April 21, 2008

DOCKET
07-BSTD-1

I have reviewed the 15-day language for the 2008 Title 24 and have a few comments for the Energy Commission to consider. I noted an omission and have several recommendations to clarify several items related to roof design. My comments focus on Section 149 and are outlined below:

CAP FLASHING TERMINATION

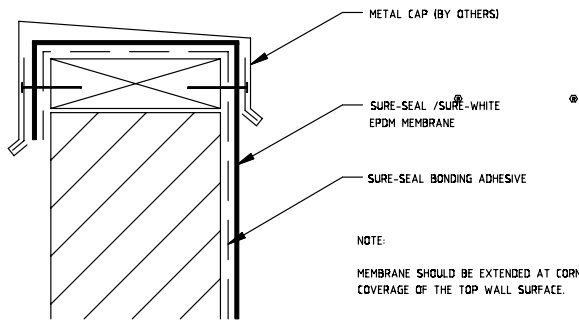
- 2) The first item is the flashing termination on parapet walls. The requirement states that an 8-inch termination above the new roof surface must be maintained. Many parapets are designed at a foot or less initially before the roof is even installed for it is only a decoration to the building. At the same time, there are many roofs that only have gravel stops at the roof edge that are kept watertight with good design. The preferred method for flashing a parapet wall is to run the membrane up and over the parapet to assure watertightness (see attachments) with a coping placed over the membrane to finish the

edge. This is generally done on parapets up to 4-feet for this wall has been known to leak allowing water to get behind a flashing termination when done on the parapet wall. It is recommended that the parapet be separated from the penthouse and the following language used.

EXCEPTION 4 to Section 149 (b)1B iv: If adding the required insulation will reduce the base flashing height to less than 8 inches (203 mm) at the parapet walls, the roofing membrane shall be run up over the parapet wall and terminated to the top of the outside wall of the parapet. The parapet is to be finished with a coping metal or other material. However, the insulation being added may be limited to the maximum insulation thickness that will allow a height of 8 inches (203 mm) from the roof membrane surface to the top of the base flashing, provided that the conditions in subsections i through iii apply:
